Further Information

**Proposed Temporary Holiday Camp, Place of Recreation, Sports or Culture
(Barbecue Site and Hobby Farm) and Eating Place with Ancillary Facilities for a Period of 3 Years
and Associated Filling of Land in "Agriculture" and "Open Space" Zones and Area shown as 'Road',
Various Lots in D.D. 17 and Adjoining Government Land, Ting Kok, Tai Po, New Territories**

(S.16 Planning Application No. A/NE-TK/832)

Response-to-Comment (RtC)

Dwg No. Figure 1

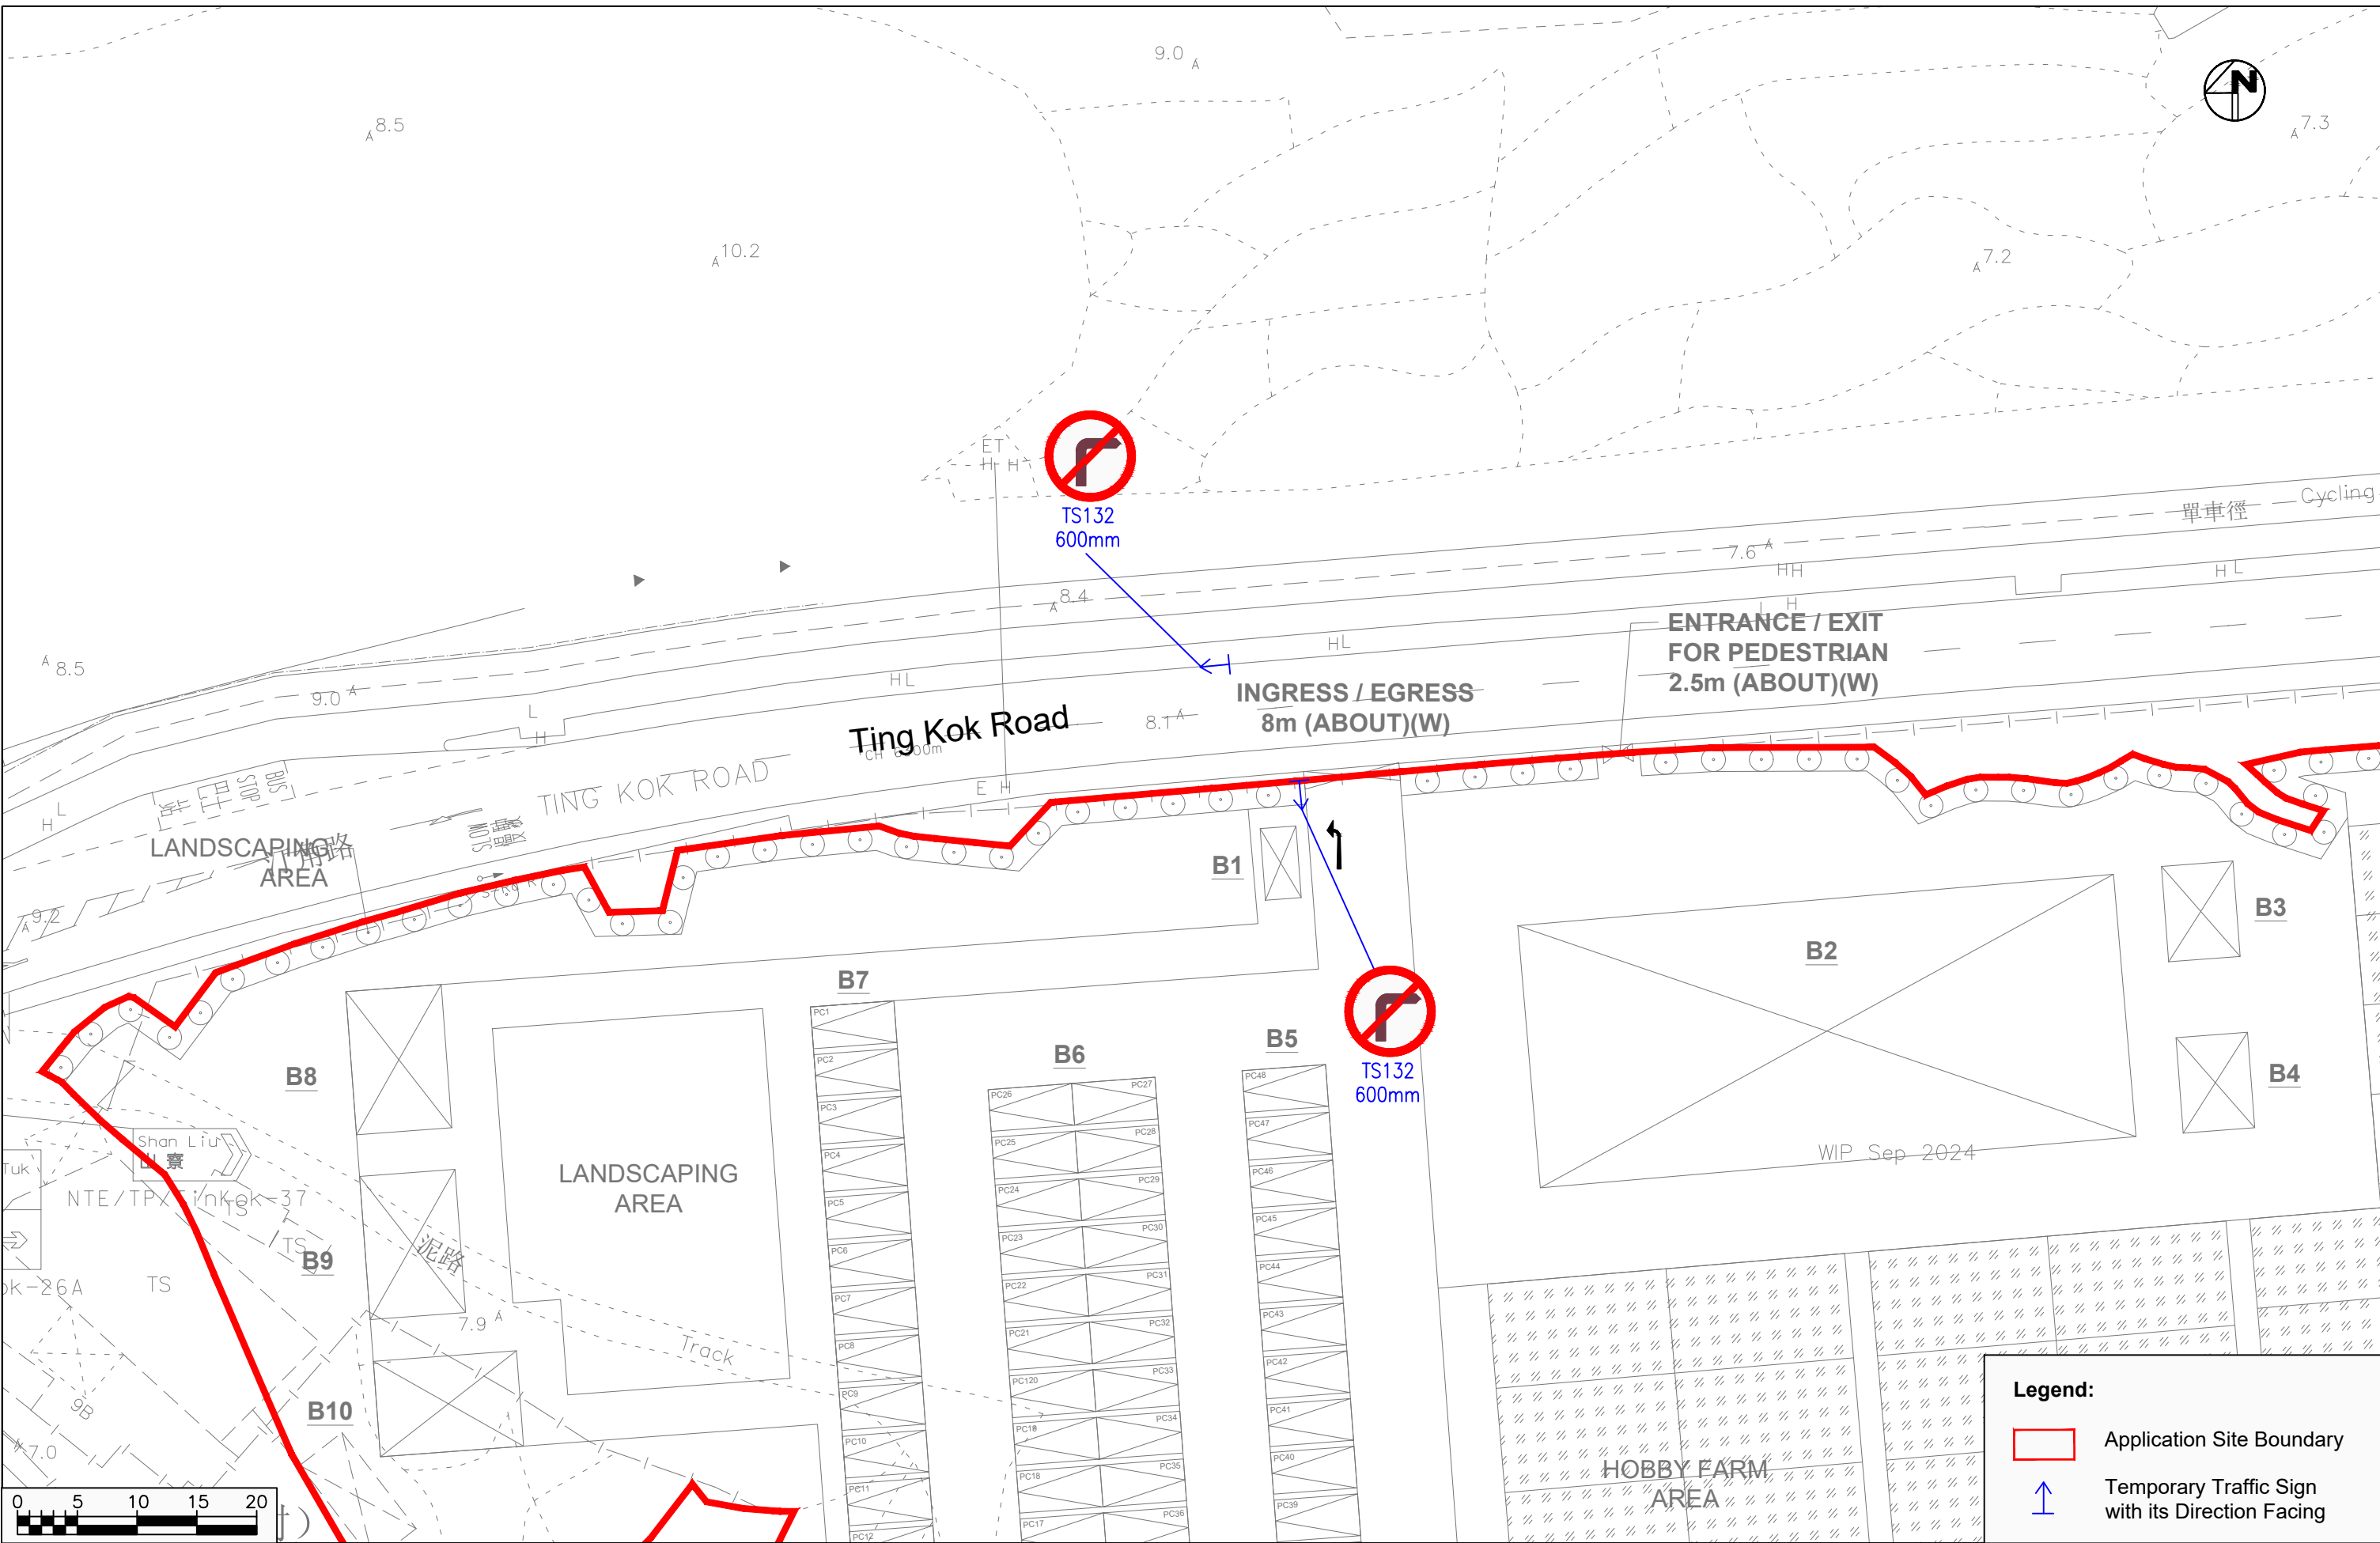
(d)	We received complaints regarding traffic congestion at Ting Kok Road eastbound due to vehicles waiting for right-turning to the access road connecting to the adjacent sites. The applicant shall provide a management plan to mitigate the potential queuing problem on the public road due to the proposed development accordingly.	Right turn from Ting Kok Road eastbound will be prohibited, and traffic signs will be added accordingly. Right turn from the Site will not be allowed. The proposed traffic sign is shown in Figure 1 and Figure 2 at Annex 1b .

PLAN 4

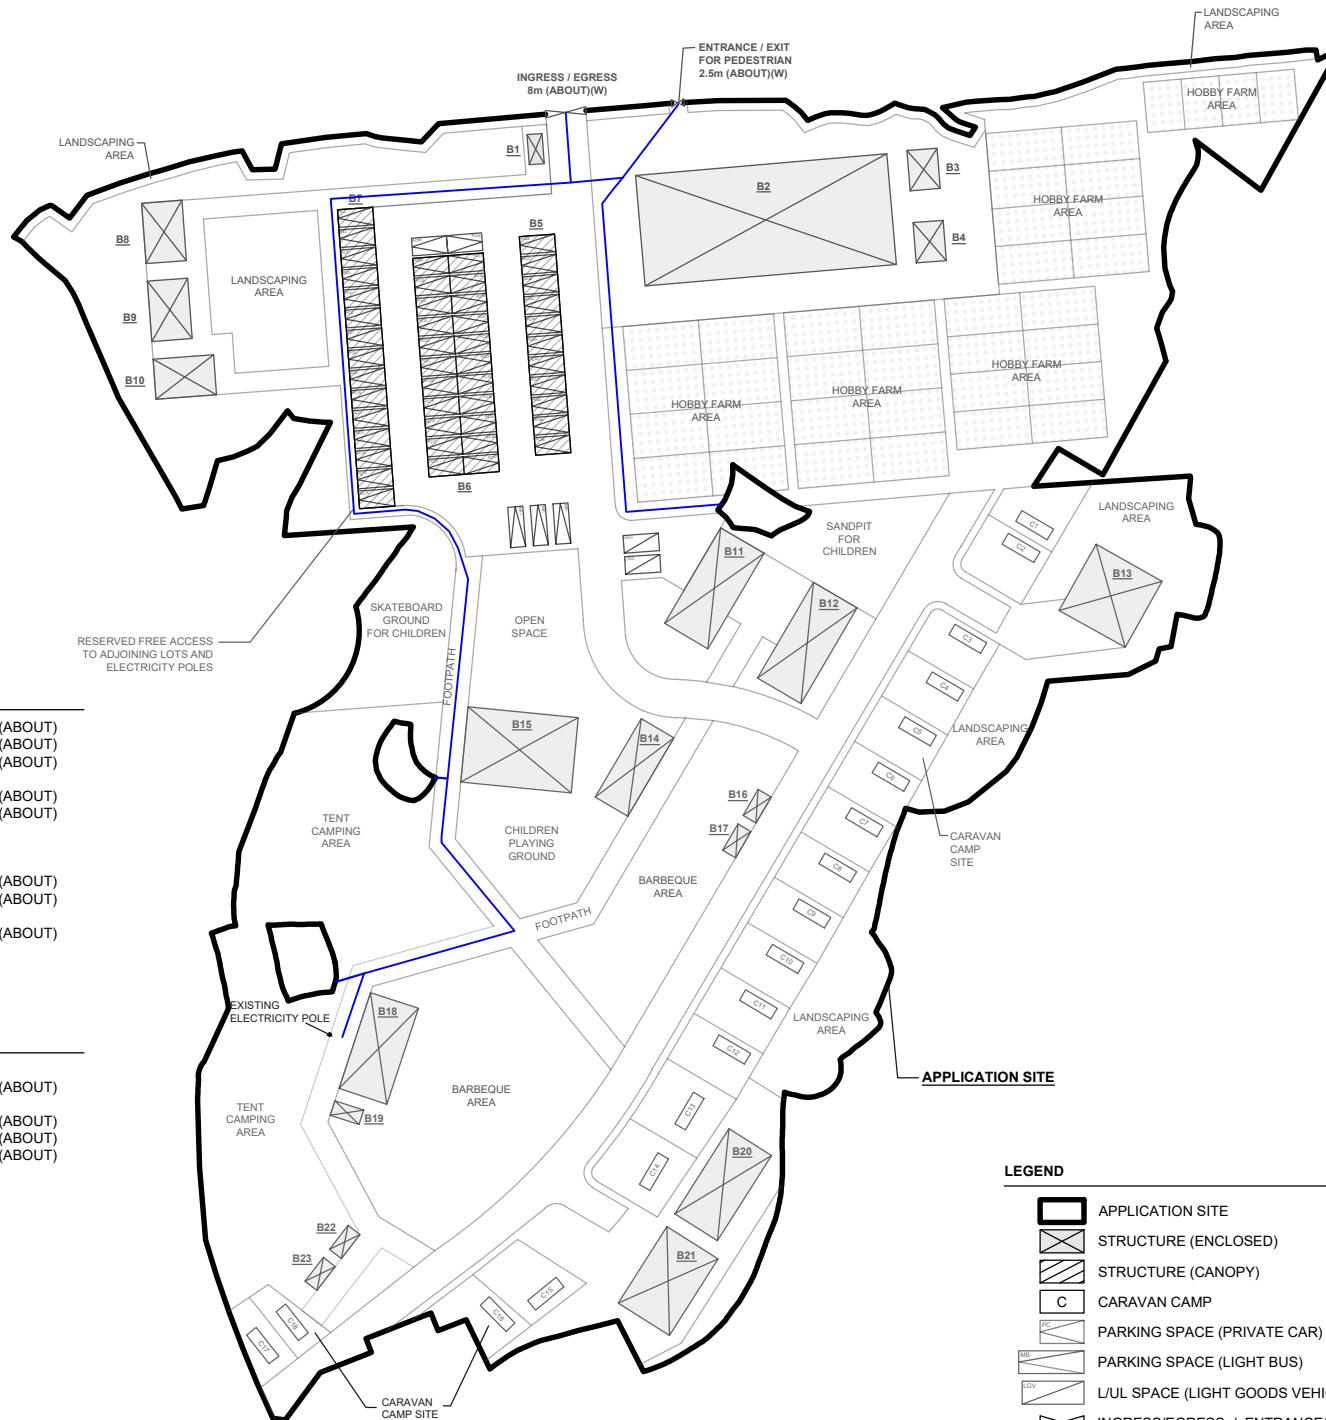
(b)	Some temporary structures are currently scattered at the Site. Please advise whether these temporary structures are intended to be covered by the current application. If yes, they should be reflected on the proposed layout plan (i.e. Plan 4).	Upon obtaining relevant planning permission from the Board, the applicant will remove the existing structures within the site boundary of the Site; and submit an application to DLO/TP, LandsD for STW for the erection of the proposed structures as shown on Plan 4.

(i)	Plan 4 – Please advise whether the height of caravan should read as “2.8 m” instead of “2.8 m ² ”.	Please refer to the revised Layout Plan at Annex 3 .

DWG NO.	VER.
PLAN 6	001

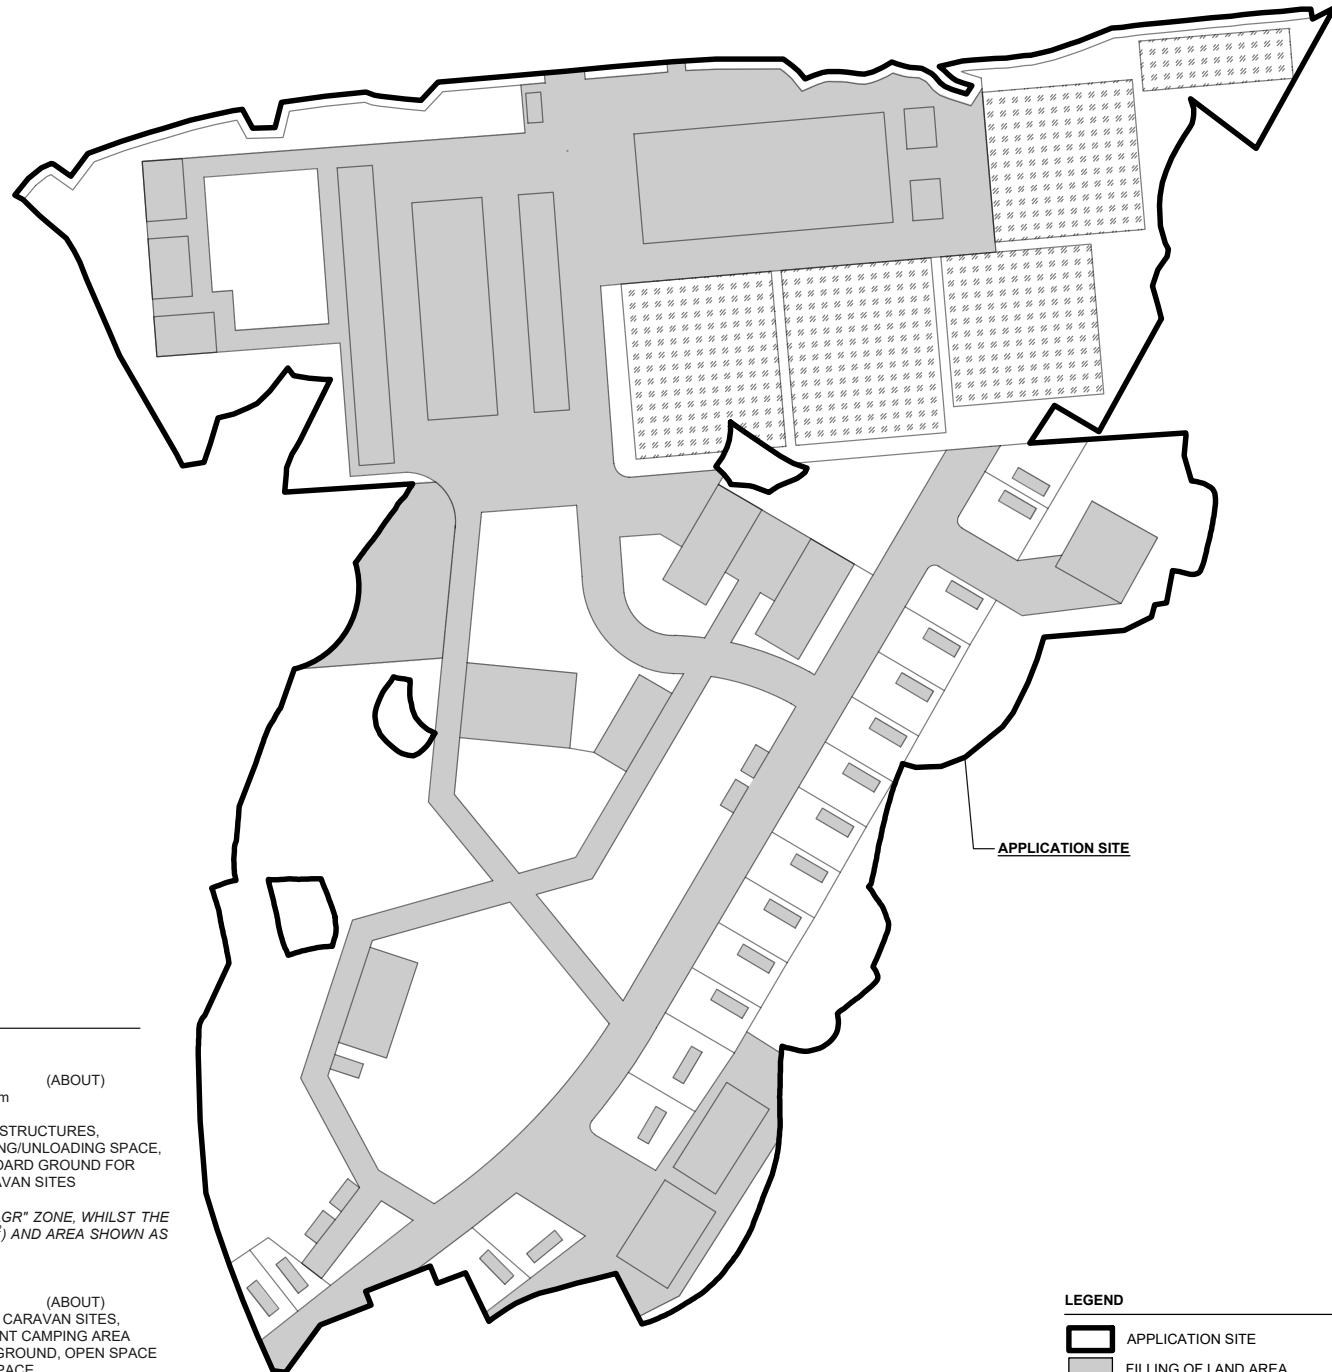
(h)	Plan 6 – Please indicate the major dimensions for filling of land areas and hobby farm areas on the plan.	The area and depth of the proposed filling of land (i.e. 15,970 m ² , 0.2 m in depth) and the area for farming (i.e. 4,117 m ²) were clearly indicated at the bottom left corner on Plan 6.

(j)	Please advise and confirm if no land filling will be carried out in the hobby farm areas.	As illustrated on Plan 6, the hobby farm areas are not included in the filling of land area (the shaded area). Hence, no filling of land will be carried out in the hobby farm areas.

(k)	Plan 6 – It seems that part of the proposed filling of land area may fall within the area shown as ‘Road’ on the approved Ting Kok Outline Zoning Plan No. S/NE-TK/19. In addition, the proposed filling of land area within “AGR” and “O” zones as stated on the plan is about 16,050 m ² (i.e. 14,599 m ² + 1,451 m ²) in total by calculation, which is larger than the total area of proposed filling of land of about 15,970 m ² stated on the plan and other relevant parts of the submission. Please check and review relevant parts in the submission for consistency, including but not limited to this plan and the DIA.	<p>The area of the proposed filling of land falling within “Agriculture” zone, “Open Space” zone and area shown as ‘Road’ are 14,384 m² (about), 1,451 m² (about) and 135 m² (about) respectively.</p> <p>Please refer to the revised Plan showing the proposed filling of land at Annex 3.</p>

(l)	Plan 6 – The proposed filling of land area, soil ground/lawn area and farm area as stated on the plan are about 31,940 m ² (i.e. 15,970 m ² + 11,793 m ² + 4,177 m ²) in total by calculation, which are smaller than the site area of about 38,338 m ² stated on the plan and other relevant parts of the submission. Please check and review relevant parts in the submission for consistency, including but not limited to this plan.	<p>Whilst the area of the proposed filling of land and area for farming remain unchanged, the soil ground/lawn area is revised as 18,191 m² (about).</p> <p>Please refer to the revised Plan showing the proposed filling of land at Annex 3.</p>
